## **COUNTRY AND MARINE PARKS BOARD**

### **Proposed Improvement to Footpath at Pak Lap, Sai Kung**

# 位置圖 LOCATION PLAN

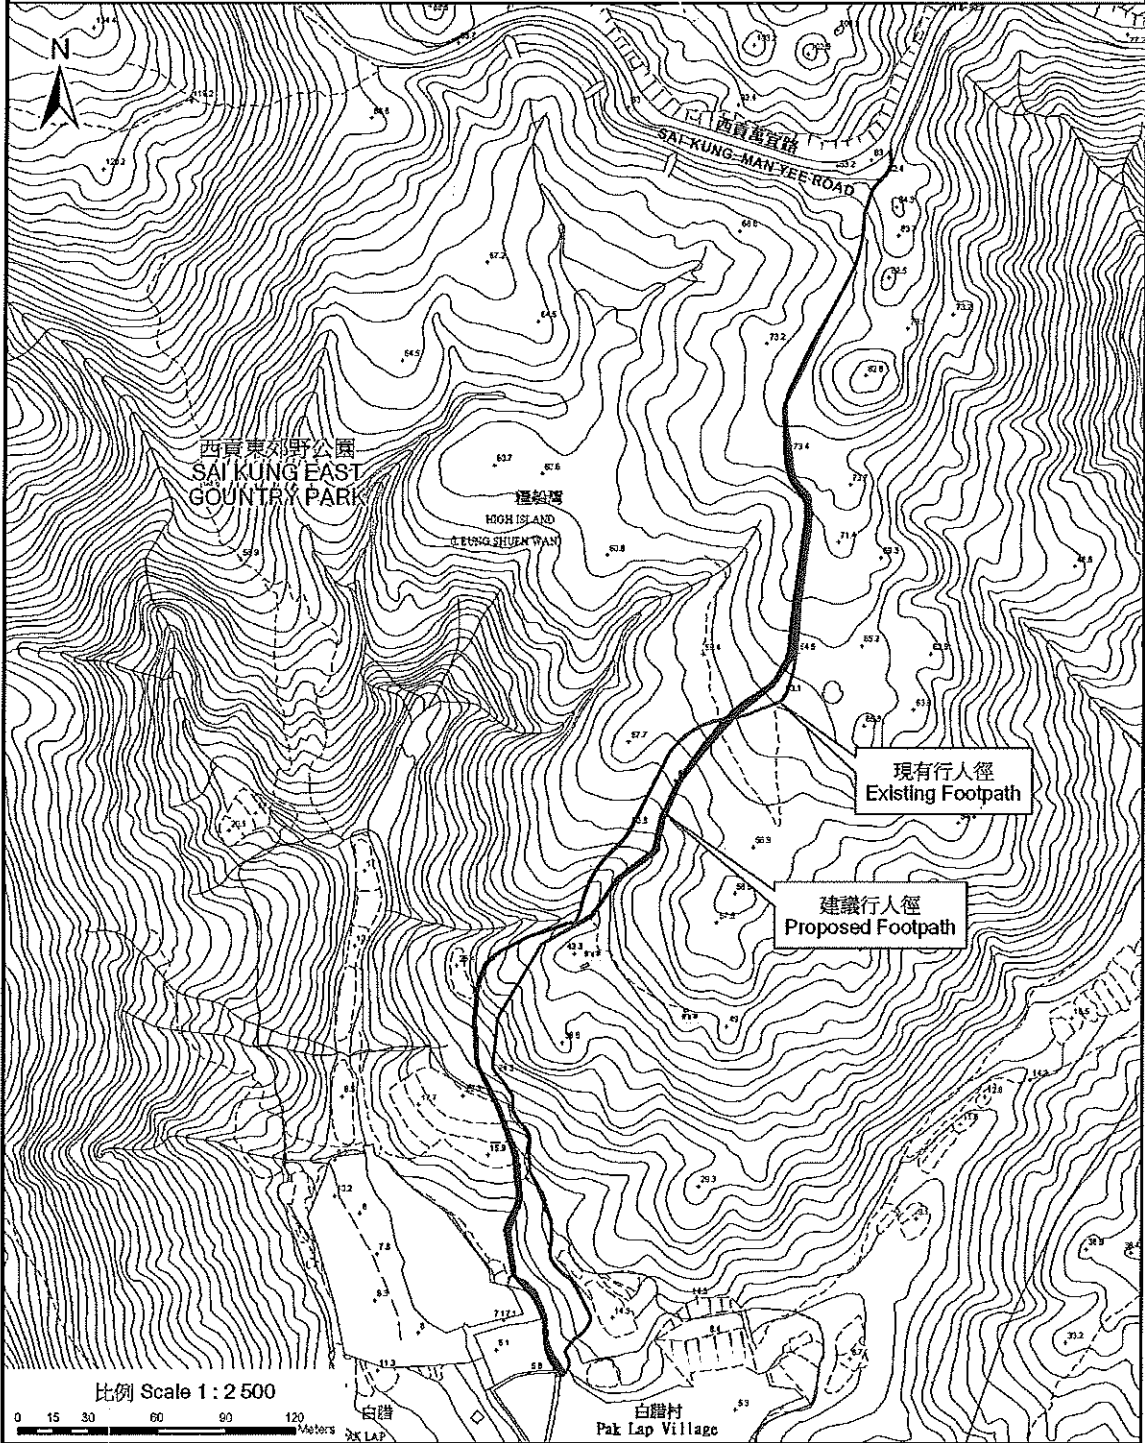
- (a) The width of proposed footpath should not exceed 1.2 metres (existing width is 1.0 metres), instead of extending to 1.5 metres;
- (b) To minimize the scale of paving, it is recommended that the proposed drainage channel along the proposed footpath should be provided on one side only and its depth should be increased to 150mm (instead of 75mm)

- (c) The proposed footpath has overlapped with the existing footpath at the starting section, i.e. CH 0 to CH 220. As this section is largely found in acceptable conditions, it is recommended only minor repairing works to be carried out in this section to minimize environmental disturbance;

- (d) The surface of the proposed new footpath should be paved by environmentally friendly materials, e.g. stone, and avoid using concrete paving as far as possible;

- (e) Hand-railing should be installed at selected sections of the footpath as a safety measurement;
- (f) There are certain retaining walls built along the existing footpath, SKDO should carefully assess the stability of these retaining walls and ensure that they would not be affected by the proposed works; in addition, SKDO should also carefully assess the need of a retaining wall along the proposed footpath built on the slope from Man Yee Road to Pak Lap village;
